# DEVELOPMENT REVIEW BOARD REPORT

### Storage 365 30-DR-2022

Request for approval of a site plan, landscape plan, building elevations, and associated improvements for a new 117,300 square foot internalized storage facility and 5,400 square foot office building on a +/- 2.52-acre site.

30-DR-2022

EL-1  
BLDG. A

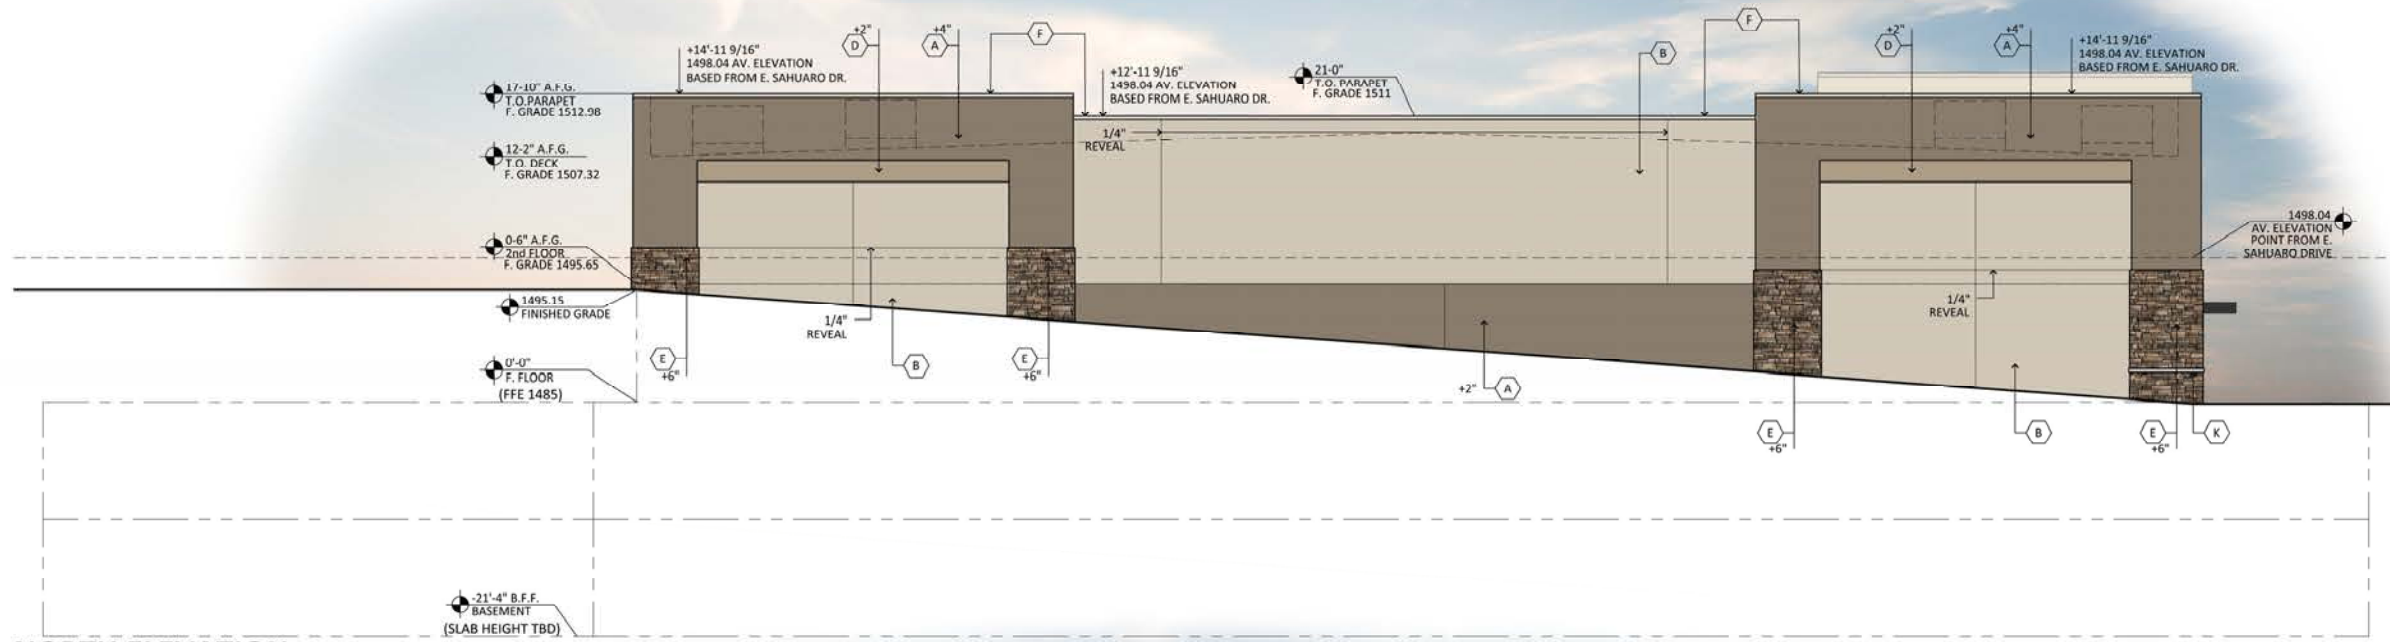
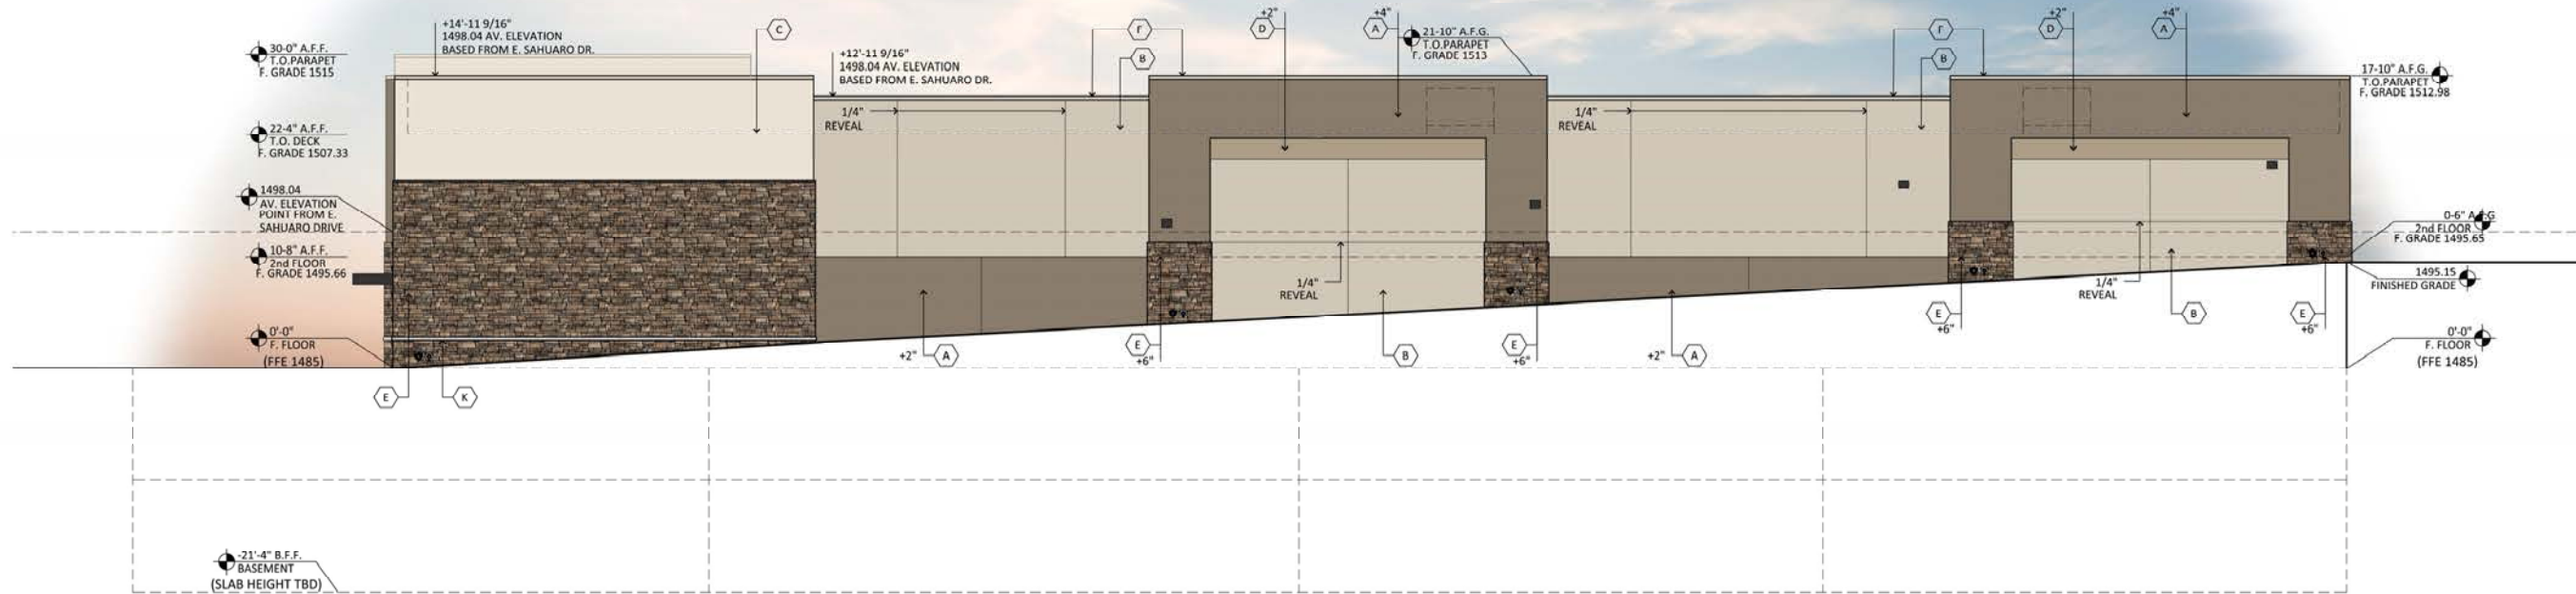
3. All exterior doors shall be recessed a minimum of thirty (30) percent of the wall depth, the amount of recess shall be measured from the face of the exterior wall to the face of the glazing, exclusive of external detailing. With the final plan submittal the developer shall provide head, jamb and sill details clearly showing the amount of recess for all door types.
4. Parapet depth shall be at least two (2) feet into the center of the building.
5. With final plans, the metal coping, identified as item F, shall be revised to have a LRV of 80 or below.

**PHOTOMETRIC SITE PLAN**

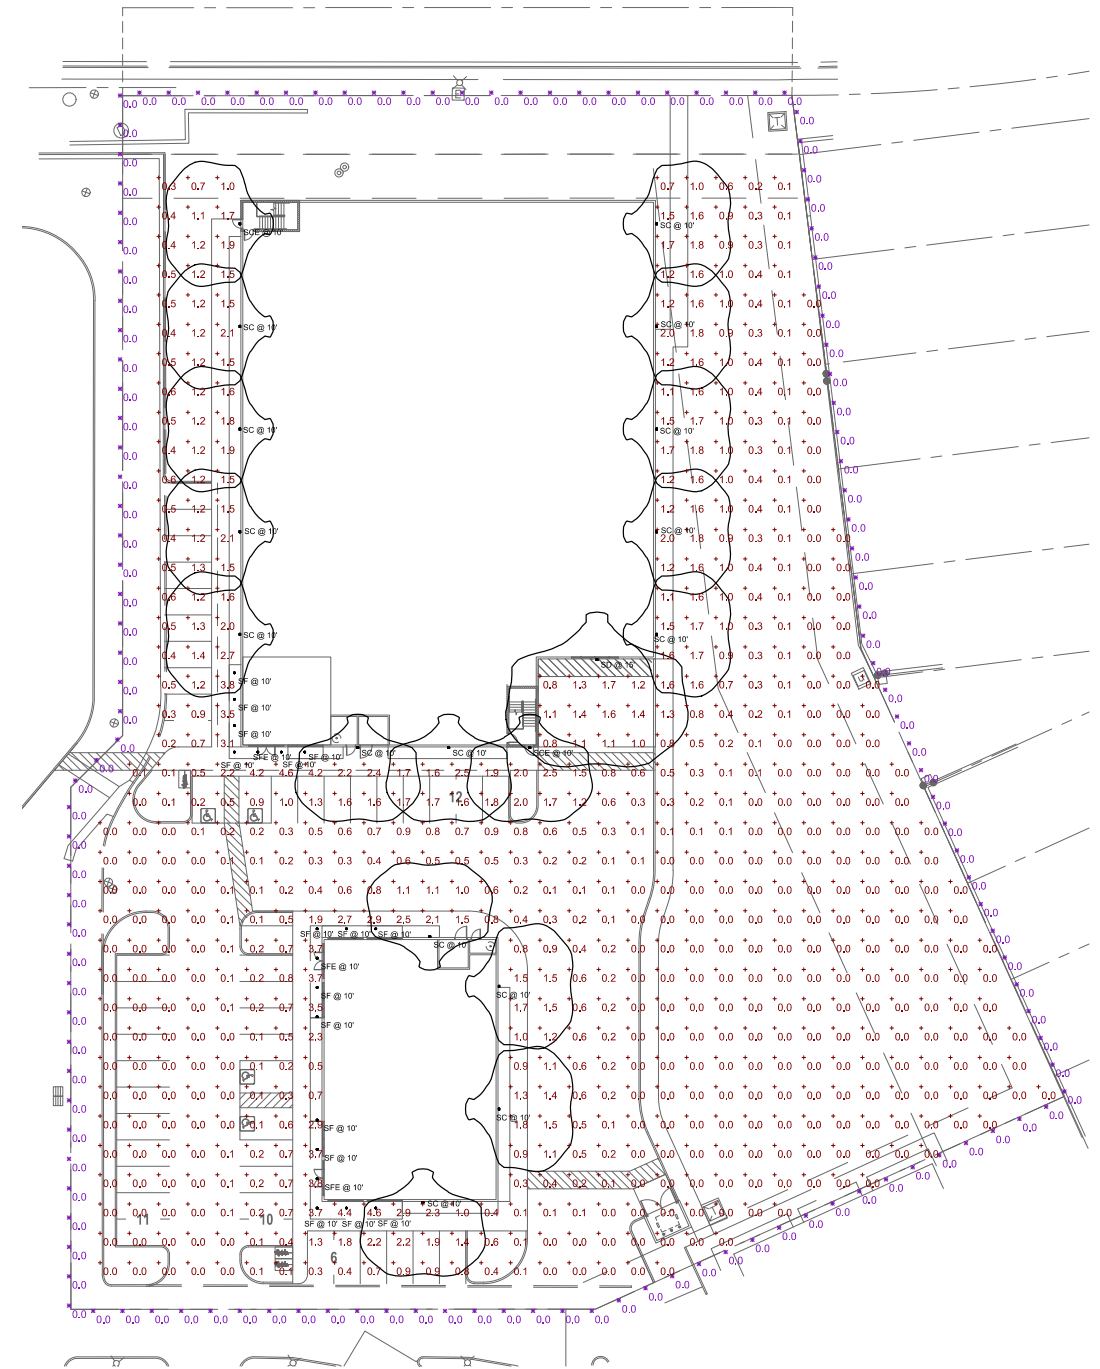
Thanks for this update, Taylor, Will is the one here who is most familiar with the lighting plans and it looked good to him. We continue to want to work together in a cooperative collaborative way and will have representatives at the public hearing if possible. Please continue to keep us updated on any further developments.

I wanted to follow up and see if you had any questions regarding the lighting plan I sent over a few weeks back or any other topic related to this site. You should have already received, or will be soon, notice regarding the public hearing coming up. We just received notice ourselves that this was moving forward.

An important issue that was originally raised in November but is not mentioned in the latest plan is that of exterior video monitoring of the site. In our own residential community adjacent to yours, we have stressed the importance of security and lighting as a deterrent to crime. We have been fortunate over the years to have had few break-ins, but have recently experienced several trespassing incidents and have had to contact Officer Hartman of the Crime Prevention Division of the SPD. As a result, we have increased our signage and continue to stress the importance of nighttime lighting. Recently, more of our neighbors have installed security monitoring. We believe that exterior lighting and video monitoring of the proposed site would decrease the possibility of crime in our community as well as on your site.

The lighting is something that we have a specific plan prepared for at this stage, so I have attached it here. It is a little odd to read if you have never looked at a photometric plan before, but I would be happy to walk a member of your association through it if you'd like. But let me try and provide some insight via this email. The specific mini numbers that cover the plan represent the number of lighting "footcandles" that exist at a particular spot on the site. So, as it gets closer to your property line, you will see that it drops to zero. That means that we are not going to be bleeding light from our project into your backyards. A little west of that spot, you will see that there is some lighting, though it is dimmer than the lighting that we have directly up against the building. Then, if you look at the building, you will see symbols and letters that represent certain types of lights. Then look at the other part of the plan to the left on page 1, and it specifically tells you what type of lighting fixture is associated with that symbol on the plan. Then when you look at page 2 it shows more detail about that light. So, you will see that along the building on the east side, we have wall lights at 10 feet high that will shine down and cast light directly beneath the light and then also eastward into the landscape area, stopping short of the shared property line.

As for the security cameras, we will definitely have cameras on the site, monitoring around the site. The details and actual placement of the cameras will be designed by our team during the construction drawing phase, which occurs after the current development review phase. But I would be more than happy to send you a copy of those plans at that time to demonstrate the coverage that we will have.
